# Determination 2024/061

**Regarding the authority's proposed decision to issue a notice to fix in relation to the construction of a cable car building, two sets of stairways, and the installation of a toilet and shower building at the property**

**589 Rocks Road, Moana, Nelson**

Figure 2: Site layout diagram, not to scale

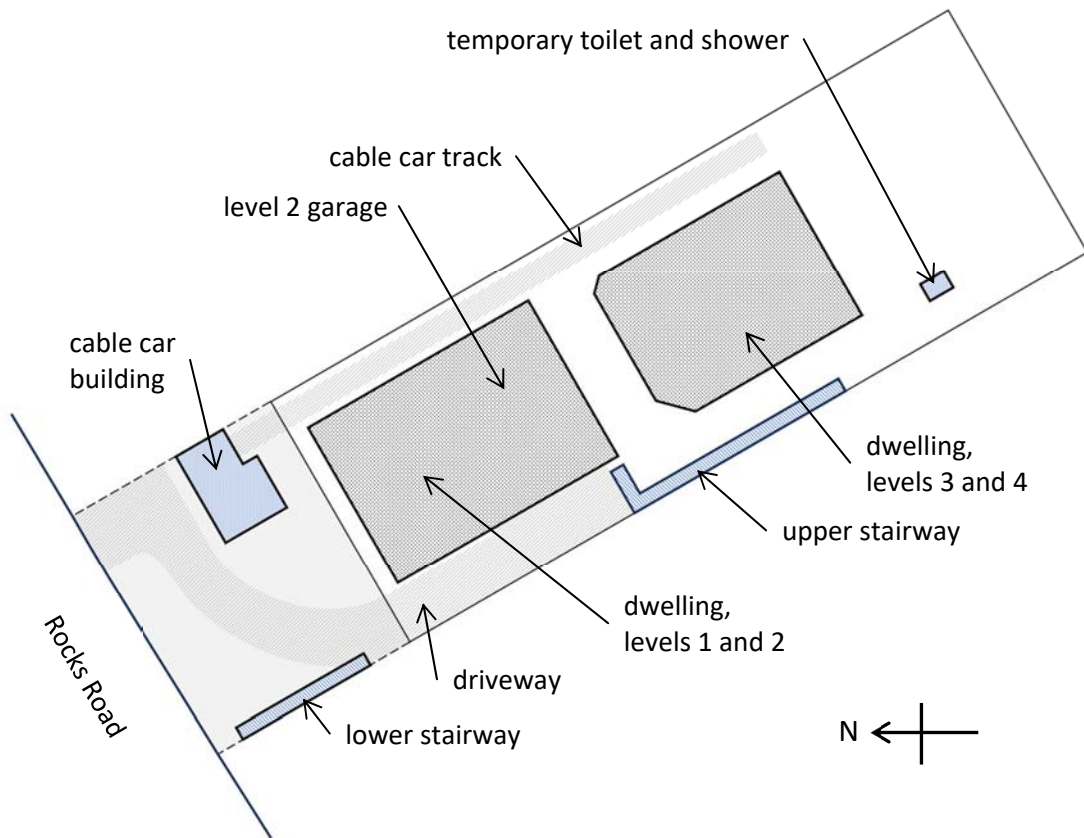
- 2.9. Two stairways run in line with the southwestern boundary of the site.
  - 2.9.1. The lower stairway is located on road reserve and runs from Rocks Road up to the midpoint of the driveway. It runs 11.06 metres long and has three even flights of stairs, climbing 4.59 meters in height.

- 2.9.2. The upper stairway runs from the garage up to levels three and four of the proposed dwelling. It includes a single flight of stairs leading from the top of the driveway up to an elevated landing, 1.53 metres above the driveway. The elevated landing is supported on two sides by retaining walls. The upper stairway then runs for 16.3 metres along the southwestern boundary of the site, climbing 4.59 meters across a single flight of stairs and then a further 3.06 metres across two even flights of stairs.

- 4.11.3. This means that the upper stairway, giving access from the garage up to levels three and four, forms part of the access route for the proposed dwelling and the performance requirements of clause D1 apply. The upper stairway therefore requires a handrail that meets the performance requirements of clause D1.3.3(j) and (k).

- 4.12. The lower stairway does not require a handrail as the performance requirements of clause D1 relating to access routes do not apply. The upper stairway, without a handrail, will not comply with clause D1.

- 5.1. In accordance with section 188, I determine, regarding compliance with the Building Code:
- 5.1.1. The upper stairway as constructed is an access route and must comply with D1.3.1 and D.1.3.3 (j) and (k). Without handrails, it does not. The lower stairway is not an access route and therefore the performance requirements of clause D1 do not apply.

- 5.1.2. The elevated landing contains a fall greater than 1 meter and does not comply with F4.3.1. A barrier must be provided which meets the performance requirements of clause F4.

Figure 3: Perspective diagram of site, not to scale

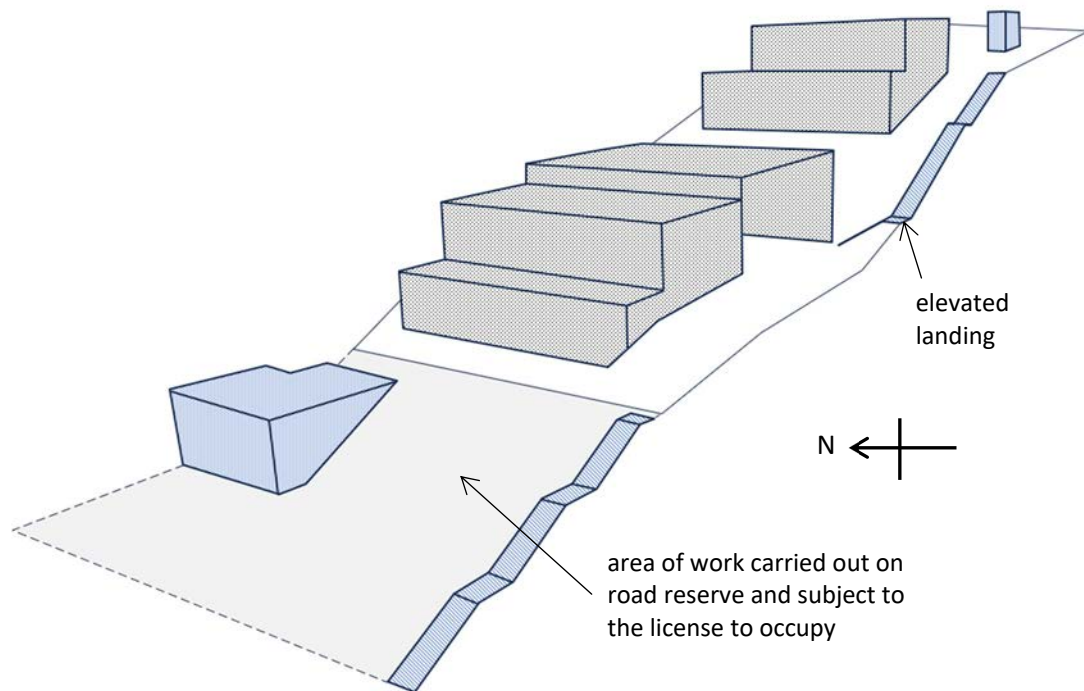
- 2.5. Some building work is located on the road reserve for Rocks Road. The owner has a licence to occupy agreement with NZTA to carry out that work. The work located on road reserve and subject to the agreement is shown in figure 3.
